Technical Memorandum

Re: Response to Comments Regarding Potential Impacts of the Replenish Big Bear Project on the Lucerne Valley Land Discharge Location

**Lucerne Valley
Land Discharge Location**
Figure 1

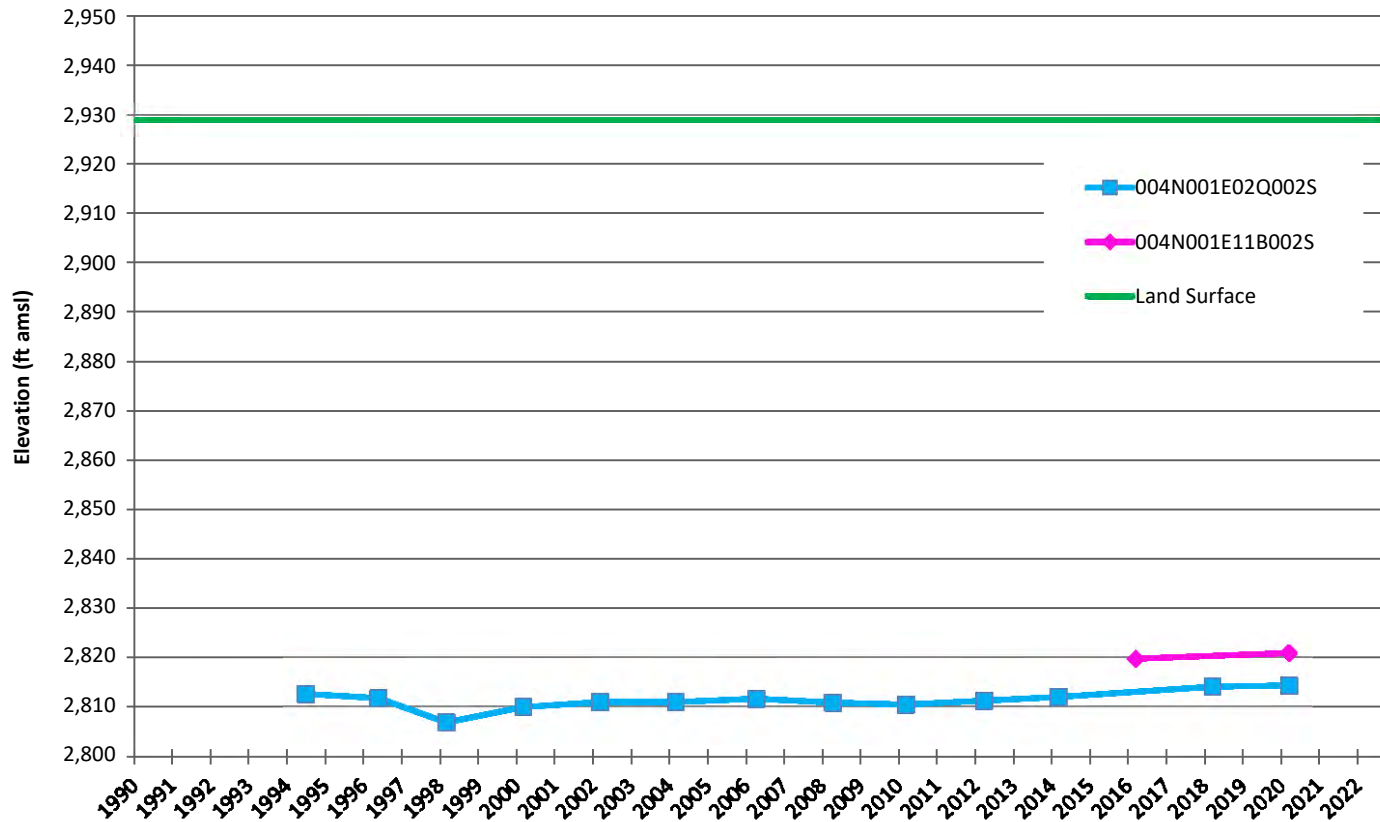
1. Have current and historical discharges to the LVDL contributed to surface or near-surface water flow in the natural wash located approximately 1-mile north of the site?
2. Have discharges to the LVDL caused higher Total Dissolved Solids (TDS) and nitrate concentrations in groundwater beneath the site than otherwise would have occurred absent the discharges?

It is assumed that the wash in question is the unnamed wash located approximately 0.8-mile northeast of the LVDL (see Figure 1). This wash is ephemeral, meaning that surface water flows in the channel only during periods of extreme above-normal precipitation. A review of historical aerial imagery (i.e. Google Earth) shows that this wash is dry in all historical images available since 1985 although its presence indicates that water has flowed in it periodically.
